Urban Perspectives Ltd
PO Box 9042
Marion Square
Wellington 6141

TDG Ref: 12834.001
13 March 2015

**North Kumutoto Precinct Project
Response to Traffic Matters Raised by Soon Kong**

Drawing Number
1.045

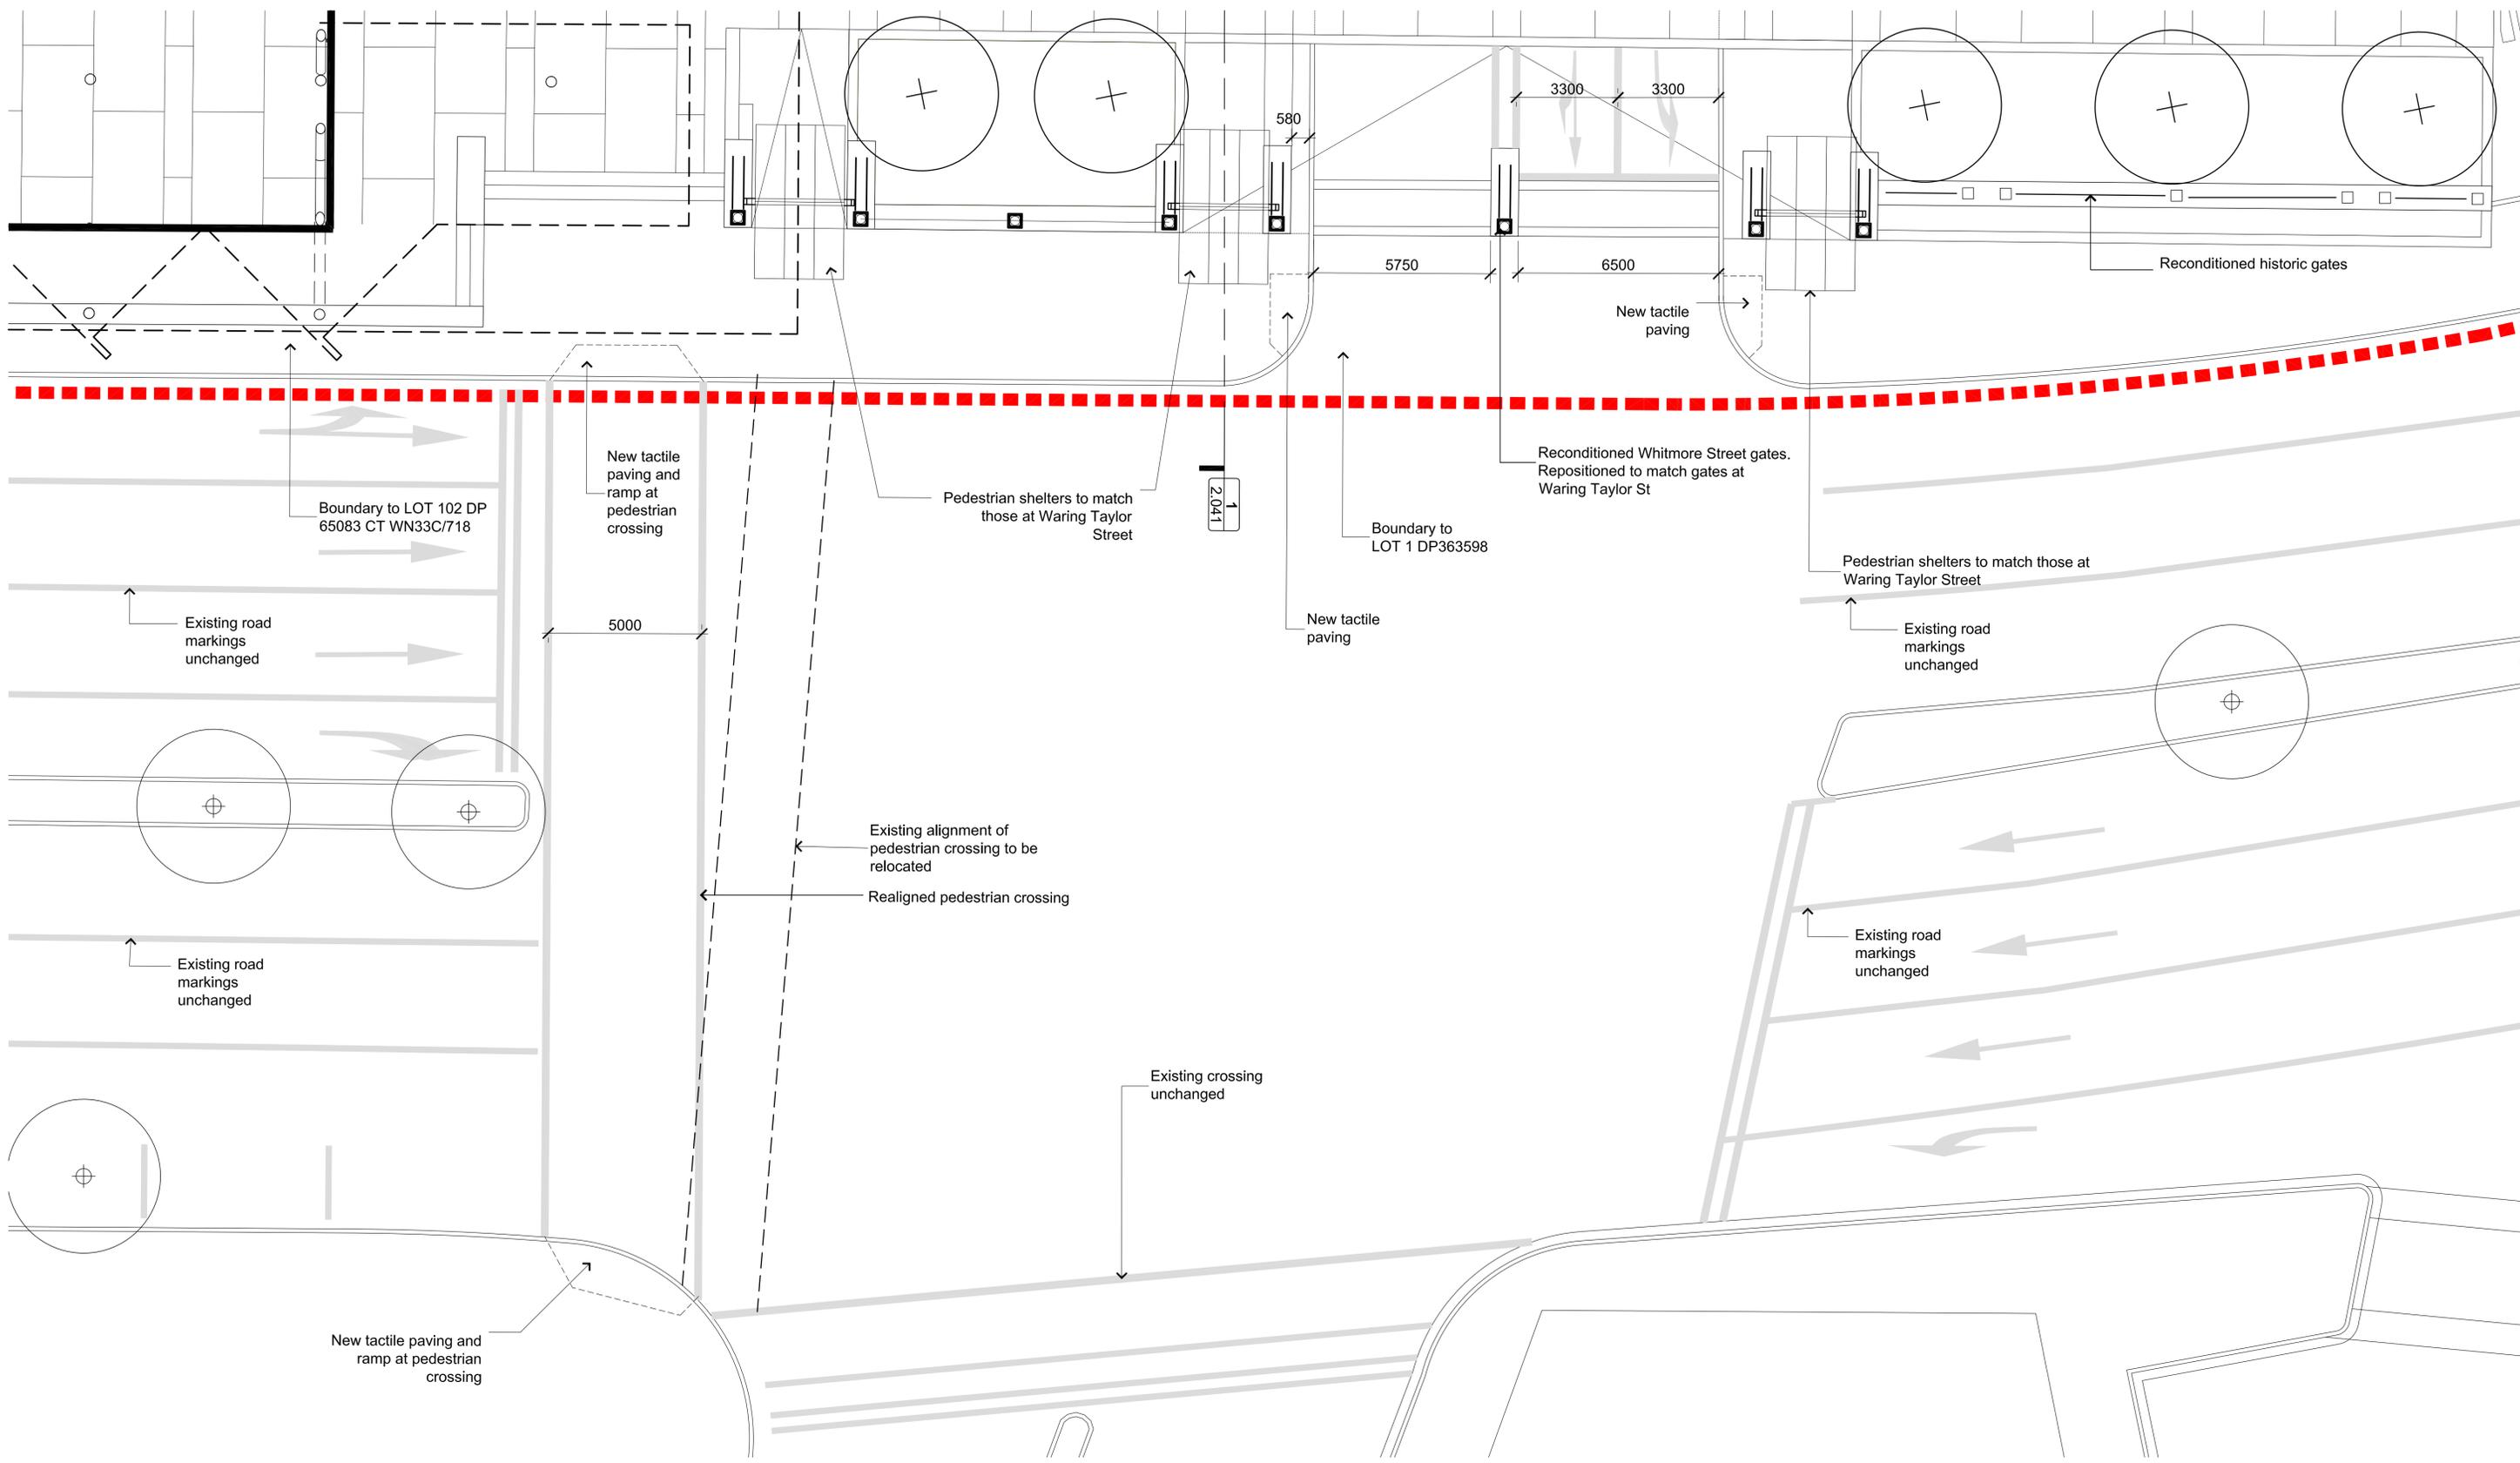
- *Item 10. Details in Drawing Number 1.045 need clarification - Red line (scope of work?), Property boundary (Public legal access), Proposed future legal road boundary, incorrect existing features and proposed pedestrian crossing.*

- *Item 10. Potential safety risk for Whitmore St approach due to the proposed Site 10 approach.*
- *Item 11. Drawing Number 1.044: Use of public road for planting and diverting pedestrians onto private land. Maintenance responsibility and Public legal access rights need to be discussed and agreed with the Council prior to consent.*

The red line shown on Drawing Number 1.045 defines the general extent of works. Some new and replacement kerbing along Waterloo Quay - Customhouse Quay is intended with the full extent of new kerbing and end tie-ins to be confirmed during detailed design.

As suggested by Soon, the proposed (realigned) pedestrian crossing has been widened to 5m. A revised version of Drawing Number 1.045 is attached.

That said, and in the manner suggested by Soon, the Applicant is prepared to mark a series of repeater right turn arrows in the length of the right turn lane between Featherston Street and Waterloo Quay.

Basement Plan
 1: 200 @ A1; 1: 400 @ A3

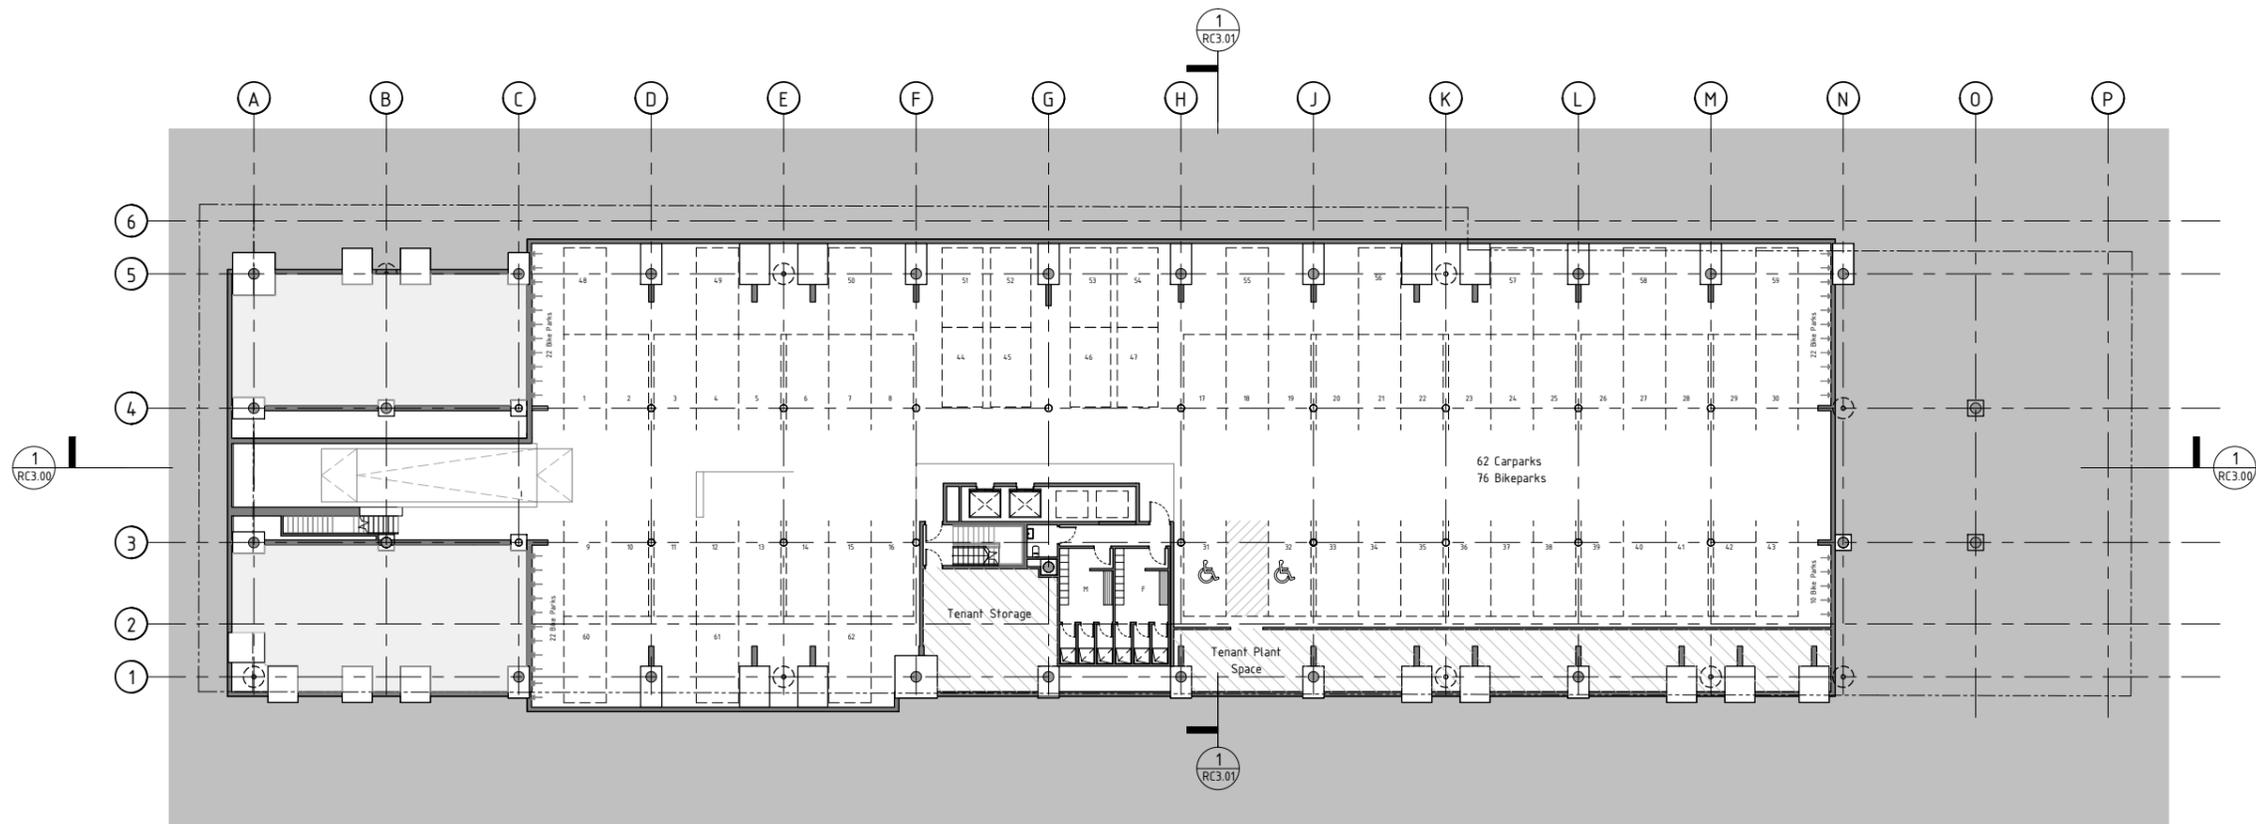
- *Item 16. The parking layout and dimensions are substandard in Drawing Number 1.046.*
- *Item 17. The single mobility carpark on the northwest corner is too far from the lift.*

In line with NZS4121, the 62-space basement carpark includes three accessible spaces.

As confirmed by discussions with a building compliance advisor (Building and Housing Group) of MBIE, the Building Code points to NZS4121 and D1/AS1 as acceptable solutions for the number of accessible spaces. In this regard, D1/AS1 requires:

- 1 accessible space for up to 10 total spaces provided;
- 2 accessible spaces for up to 100 total spaces provided; and
- 1 more accessible space for every additional 50 spaces.

As such, two accessible spaces can be regarded as acceptable in this instance, as proposed adjacent the lifts. An updated basement plan (RC1.01 – B prepared by Athfield Architects) is attached.

In relation to the initial comment of proximity of the northern mobility carpark to the lifts, I have confirmed with the same contact at MBIE that there is no standard requirement for a maximum distance from a mobility carpark to a lift. Rather, best practice suggests that spaces should be 'reasonably close' with access along a flat and smooth surface and undercover, each of which would have been met in the event the third (northern) mobility space remained but, as above, it is now proposed to revert to a standard carpark.

Drawing Number
1.047

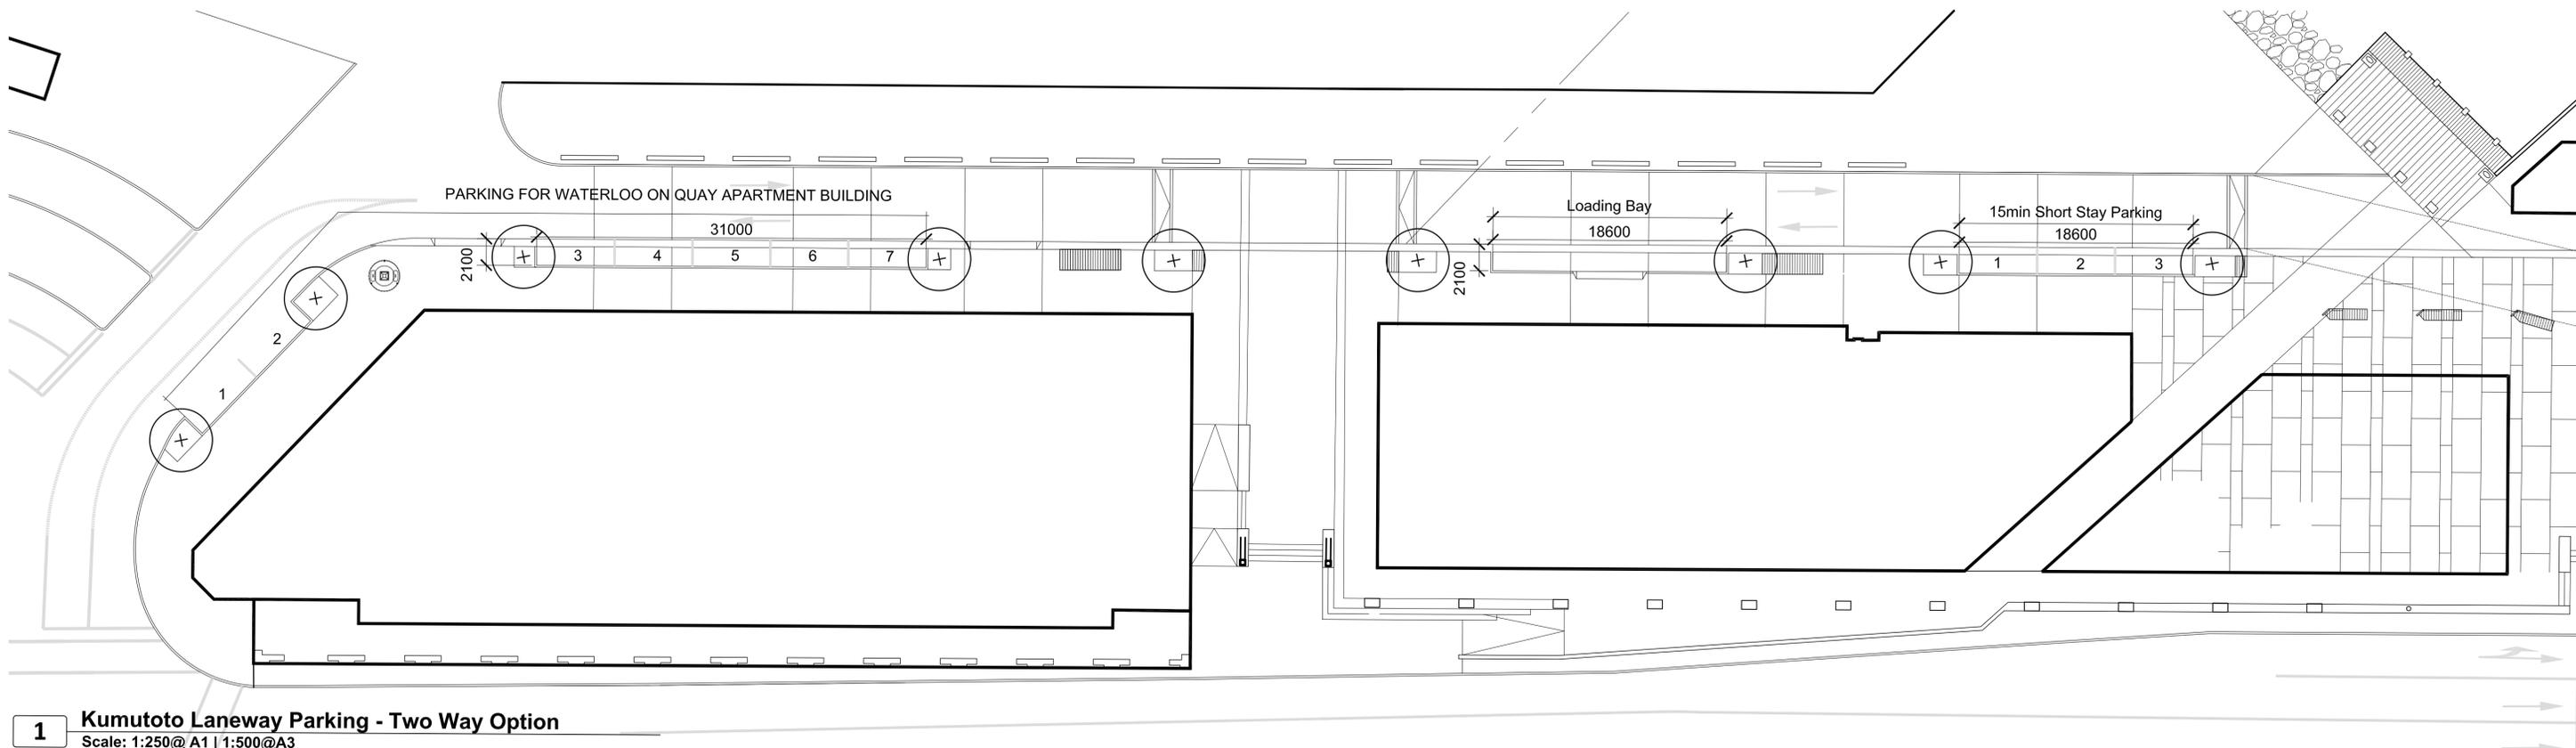
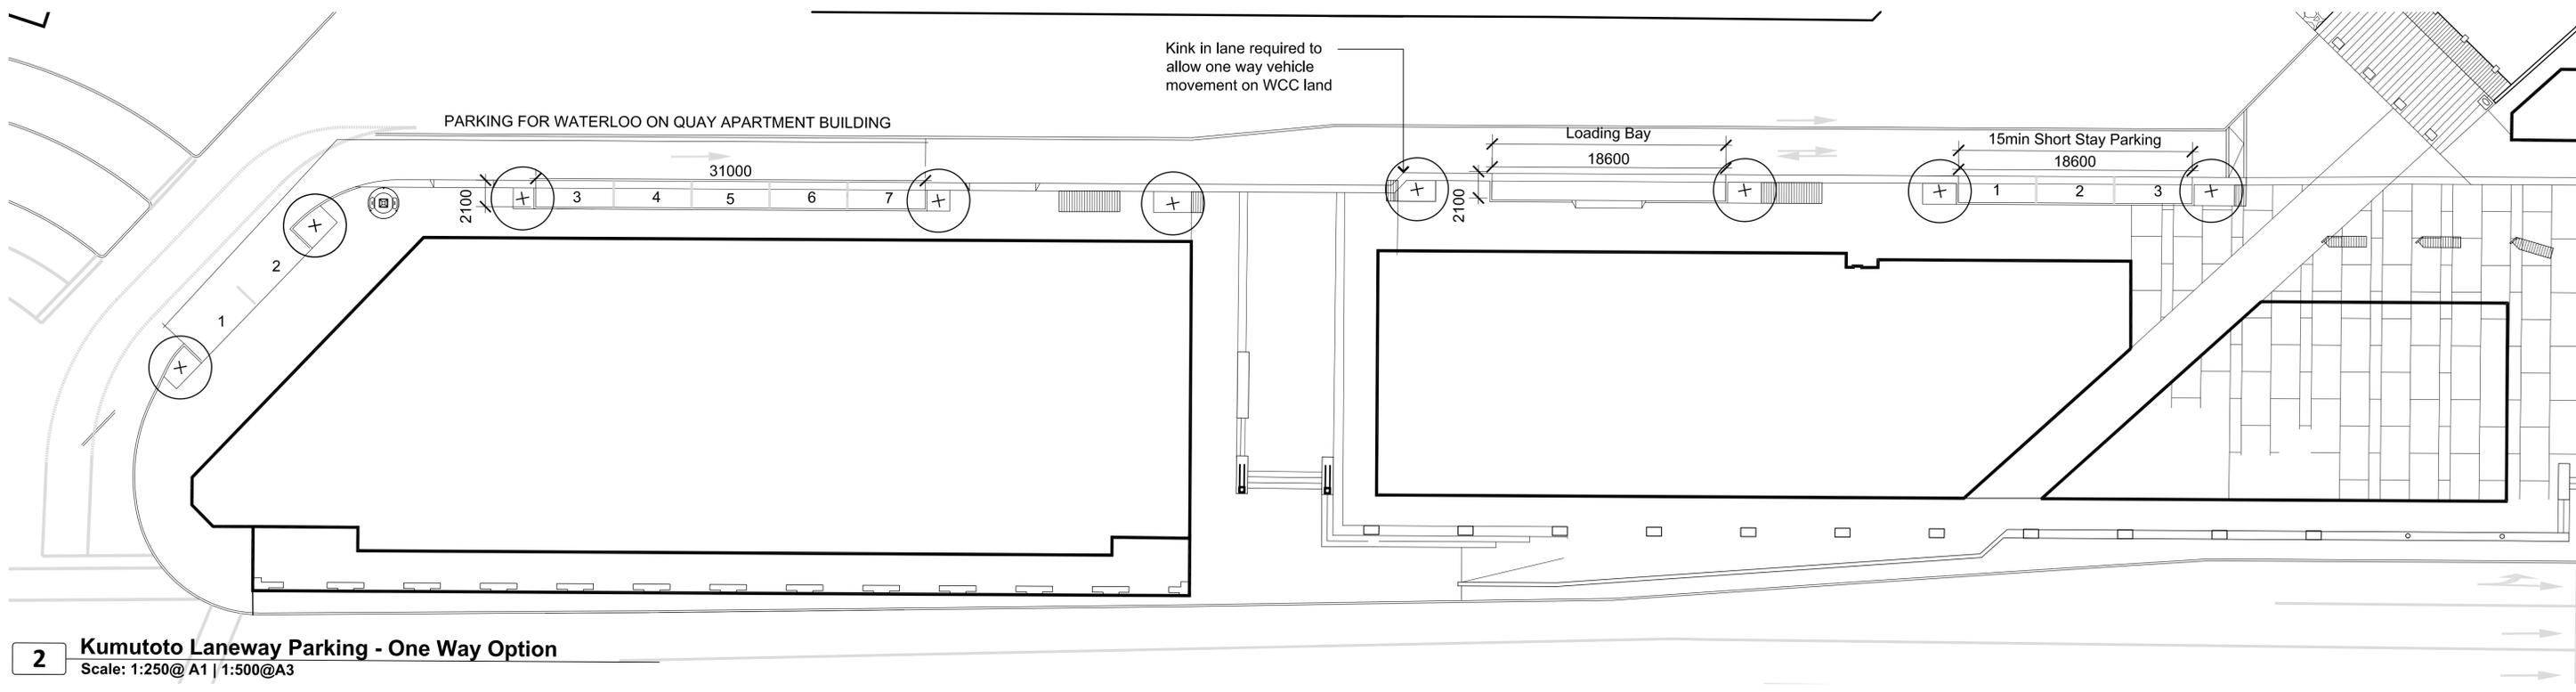
- *Item 21. Where is the dedicated kerbside servicing zone for larger vehicles to use for loading and unloading? The proposed loading bay within the building will only accommodate smaller service vehicles.*

Drawing Number 1.047 prepared by Isthmus, as attached, shows the proposed kerbside loading zone, for the two-way and one-way lane designs.
